Ref: 740.DA5.320.002

## **RESPONSE TO INFORMATION REQUEST LETTER**

**DEVELOPMENT APPLICATION FOR A MATRIAL CHANGE OF USE – DEVELOPMENT PERMIT FOR EXTRACTIVE INDUSTRY AT THE EXISTING BROMELTON NORTH QUARRY ON LAND SITUATED OFF SANDY CREEK ROAD, BROMELTON, QLD 4285, PROPERLY DESCRIBED AS LOT 1 ON RP98576**

### **OFFICE OF COORDINATOR GENERAL REFERENCE: AP2022/022**

DRAWING NUMBER: **740.DRG.166**  
 REVISION: **17**

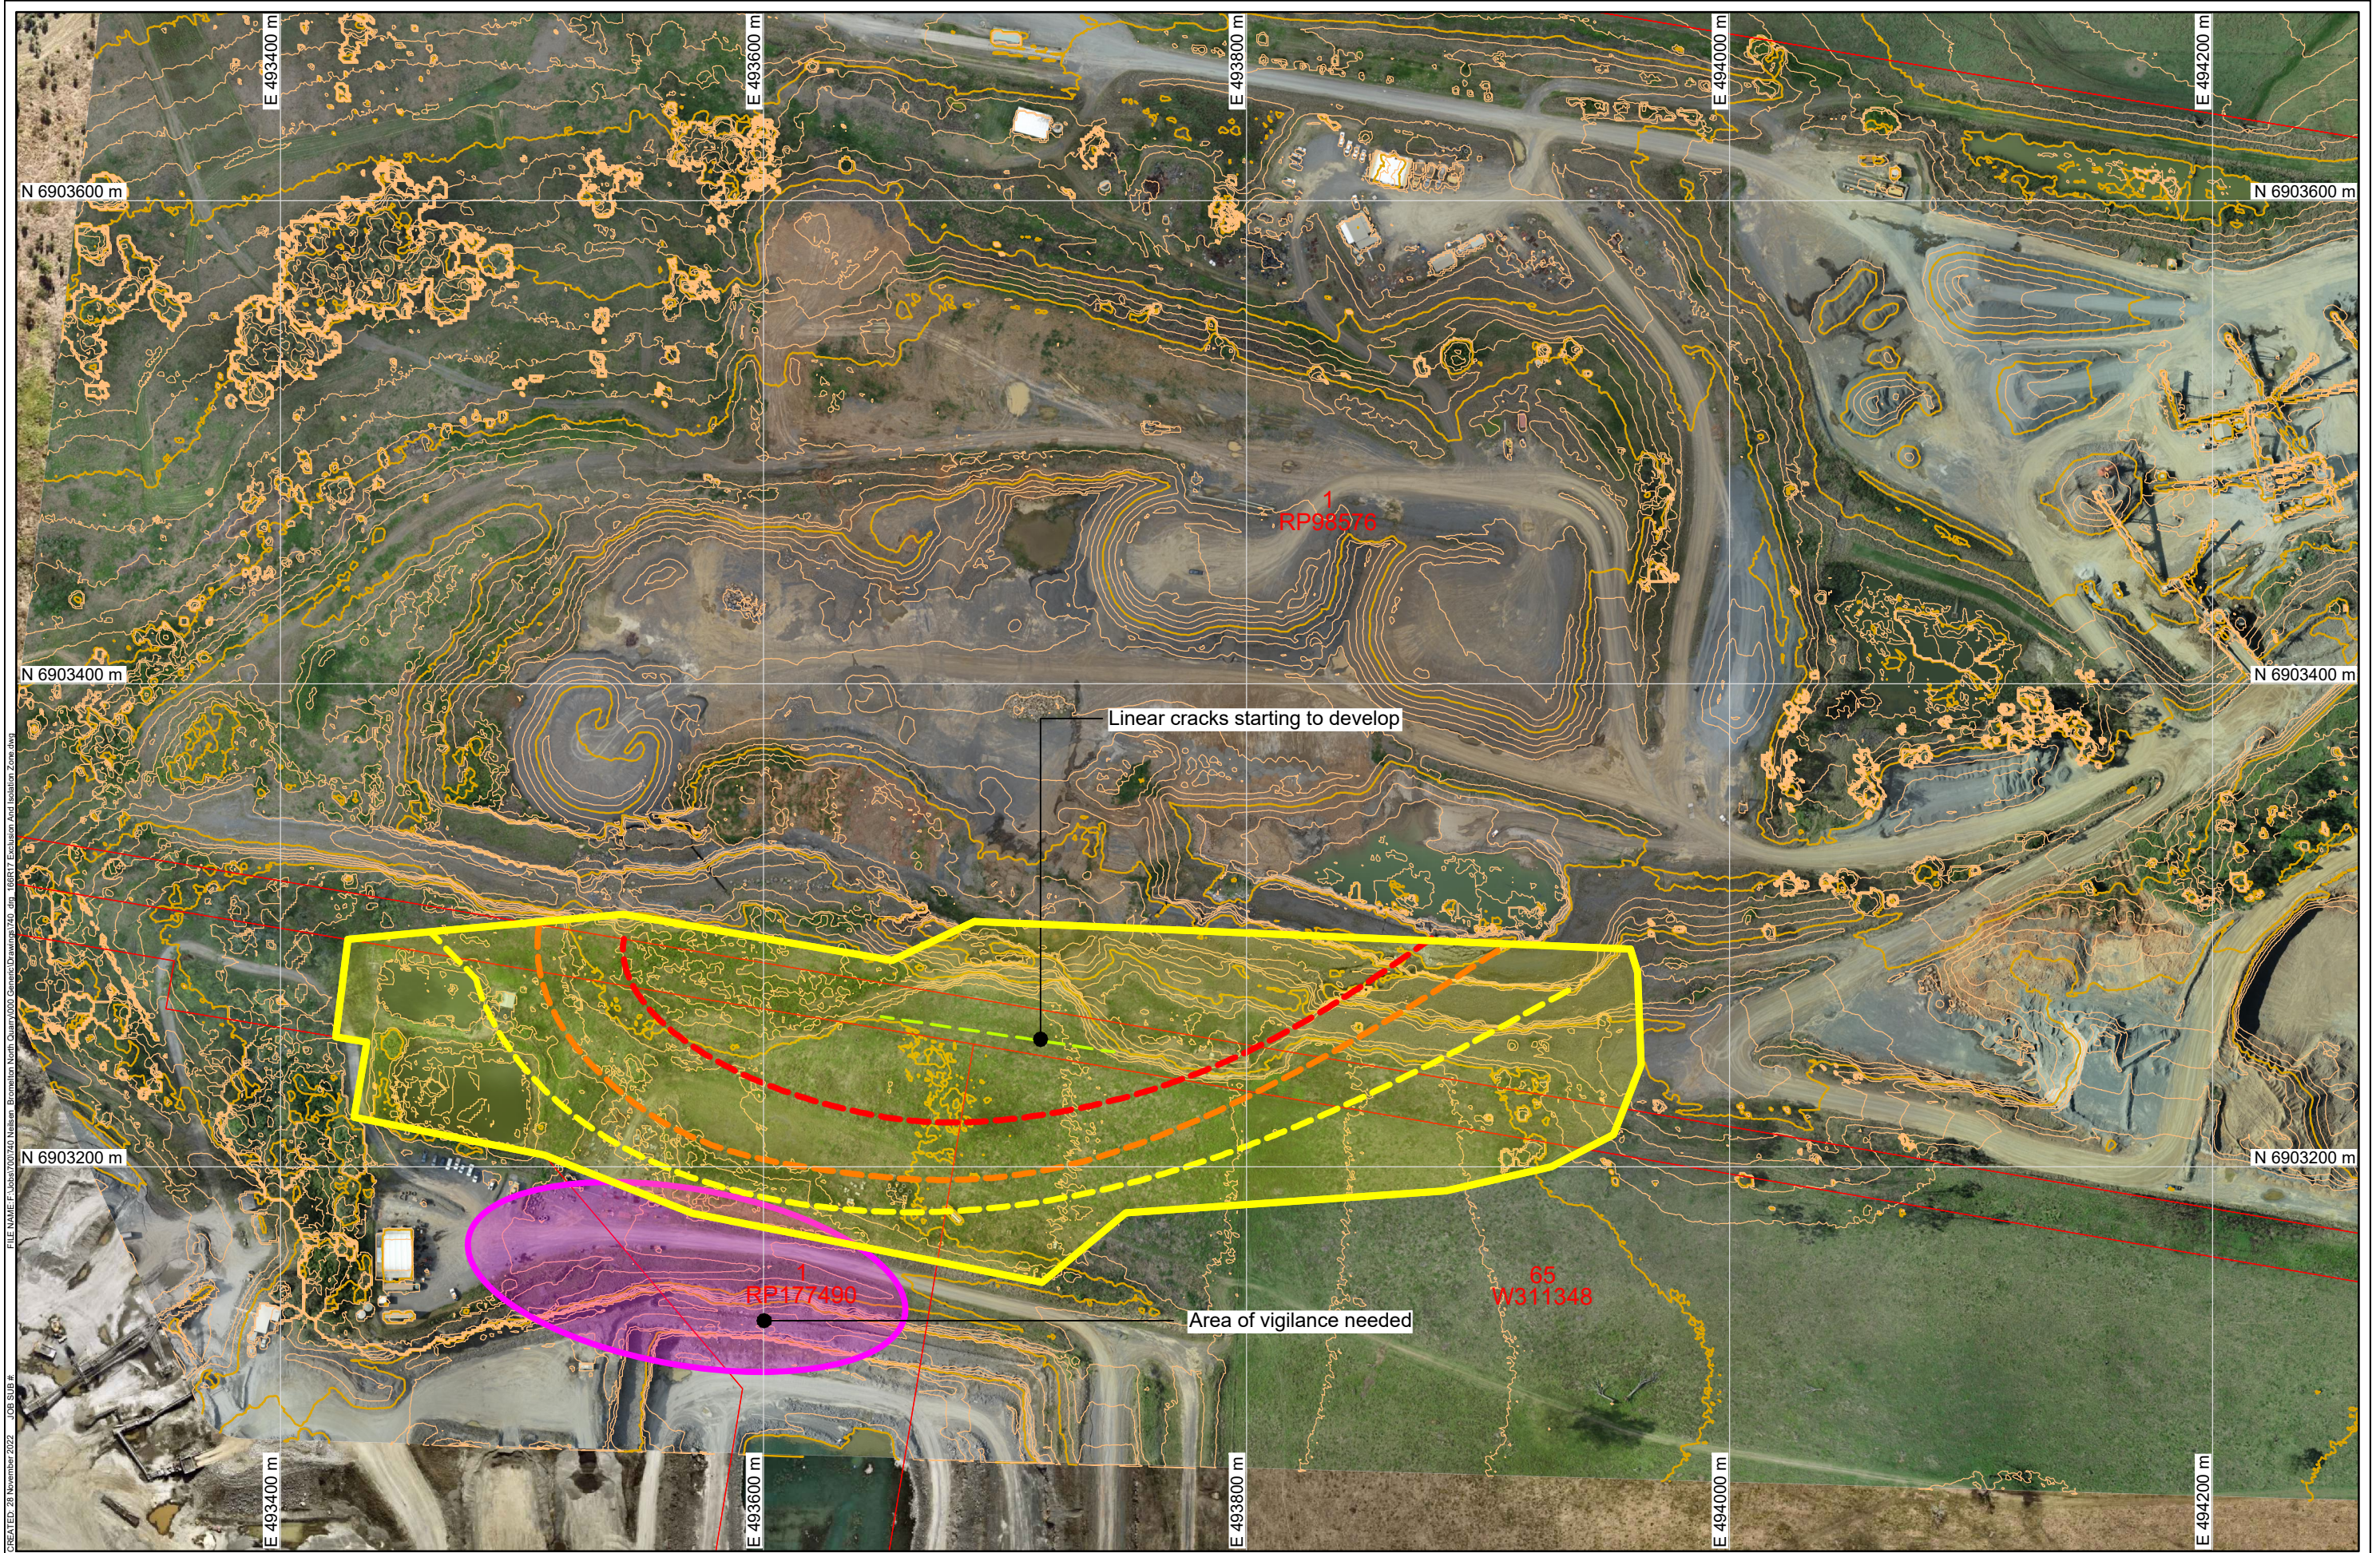
- Landslip: Neilsens' has been working closely with the Department of Environment and Science ('DES') in relation to a landslip on the southern wall of the West Pit. To date this matter has involved liaison with landowners on either side of the property boundary, Council, DES, Department of Resource and Department of Agriculture and Fisheries.

An exclusion and isolation zone has been established to assist in managing the landslip. This area is re-assessed as stabilisation works are undertaken and risks are re-evaluated. The current exclusion and isolation zone has been attached for the Departments information purposes (refer **Appendix F – Exclusion and Isolation Zone**).

*Influence on current Development Application:* A final geotechnical solution is yet to be agreed between all parties. However, intermediate steps have been taken to stabilise the slip, including filling within the West Pit void. The final geotechnical solution will define the land use approval process required (i.e., Operational Works through Council or MCU through the Department). It is premature to include or exclude this area from the extraction footprint.
